13-May-2025 - Redlines - DD

Lot 37 - Duncans Creek

Smithfield - LH  
'FRENCH COUNTRY'  
ELEVATION

THE SMITHFIELD - LH

FIRST FLOOR PLAN 'FRENCH COUNTRY'  
SCALE: 1/8"=1'-0" ON 11x17, 1/4"=1'-0" ON 22x34

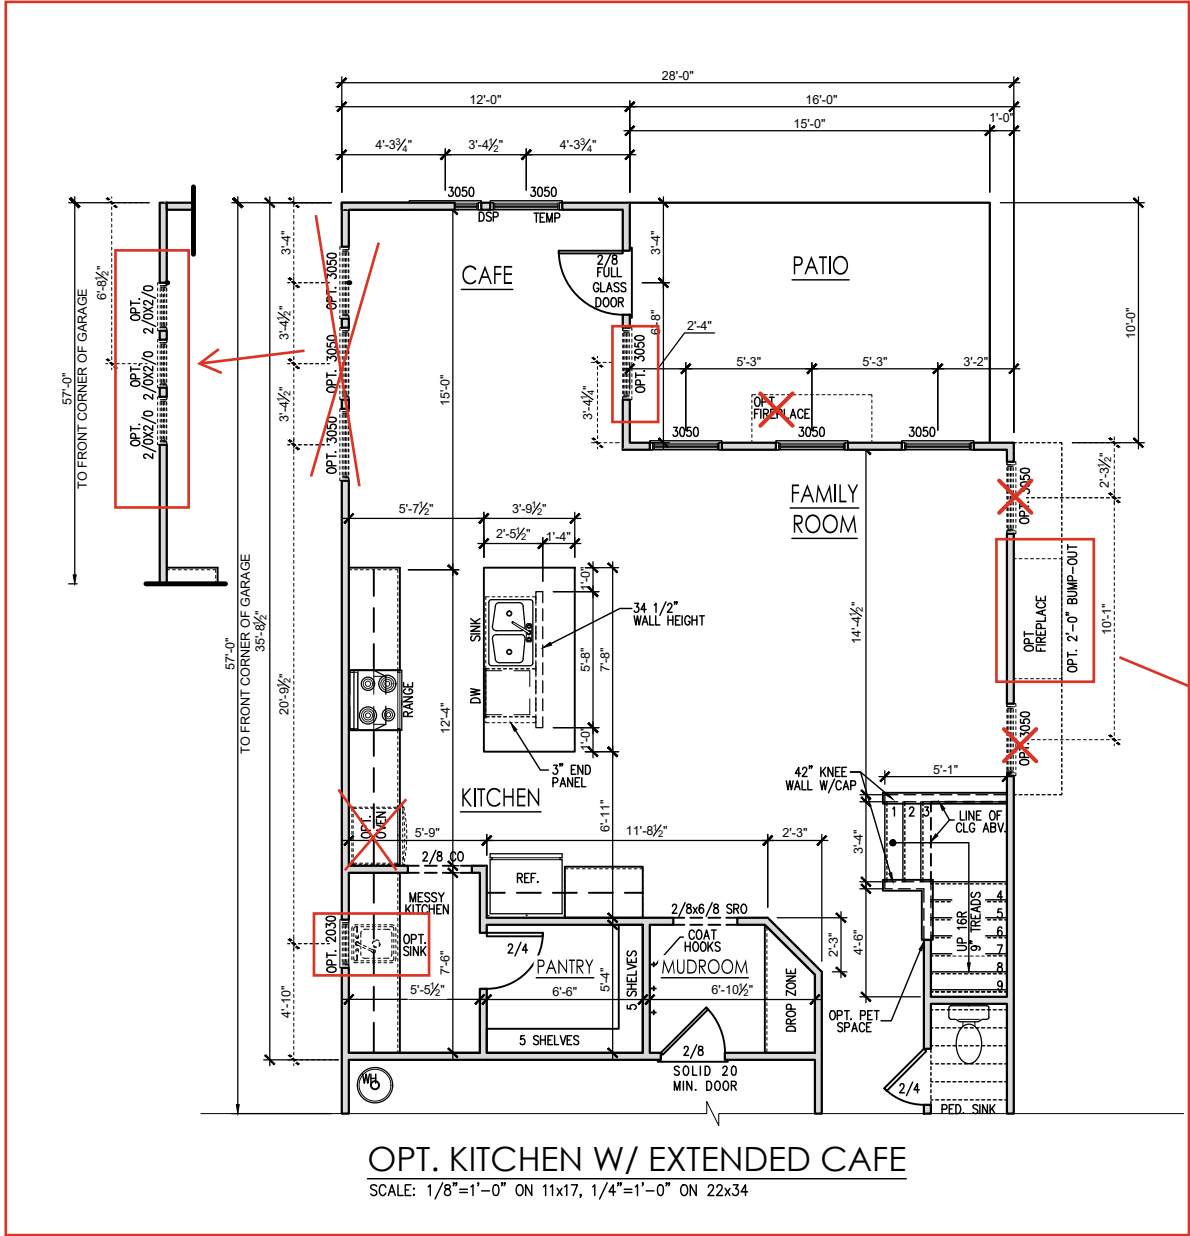
Extended Cafe - 2.1.1b

Side Fireplace - 2.1.1b

Smart Door Delivery

SECOND FLOOR PLAN 'FRENCH COUNTRY'  
SCALE: 1/8"=1'-0" ON 11x17, 1/4"=1'-0" ON 22x34

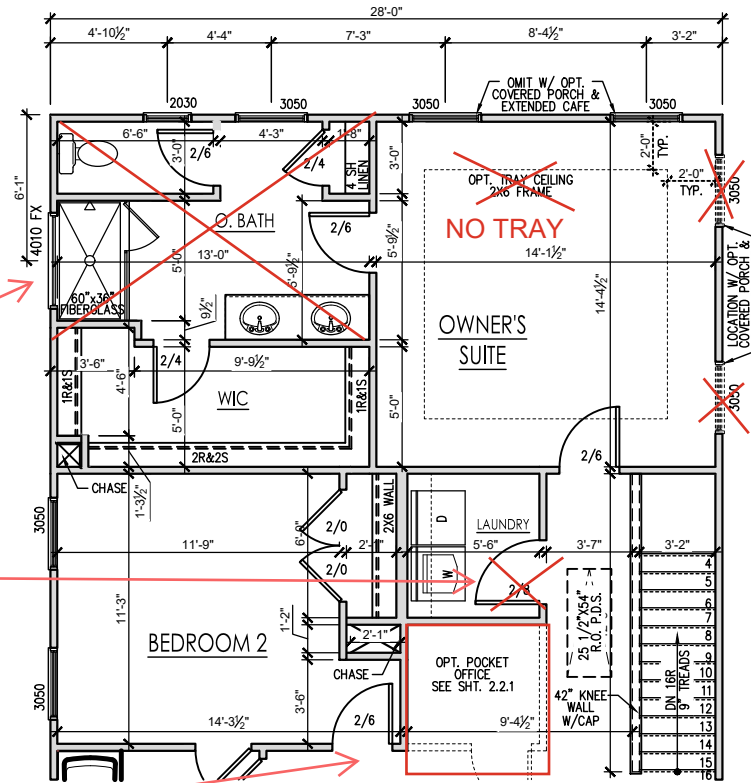
CHANGE  
LAUNDRY ROOM  
DOOR TO 5/0 DBL  
SWING OUT

Pocket Office - 2/6  
FULL GLASS door

SECOND FLOOR PLAN "FRENCH COUNTRY"

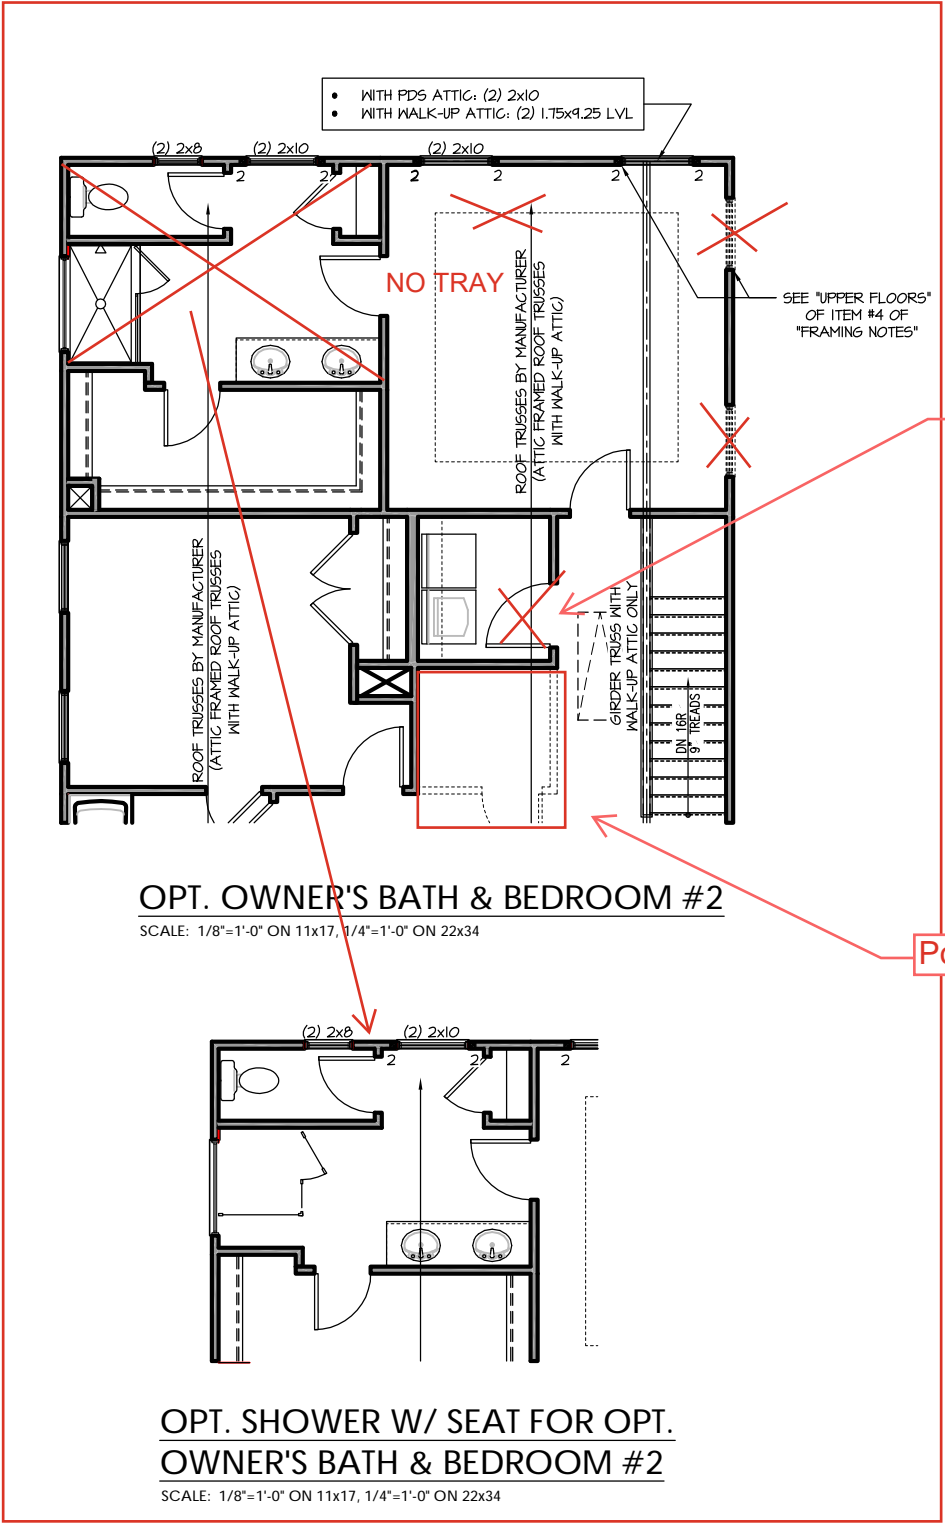
CHANGE DOOR  
TO 5/0 DBL  
SWING OUT

Pocket Office
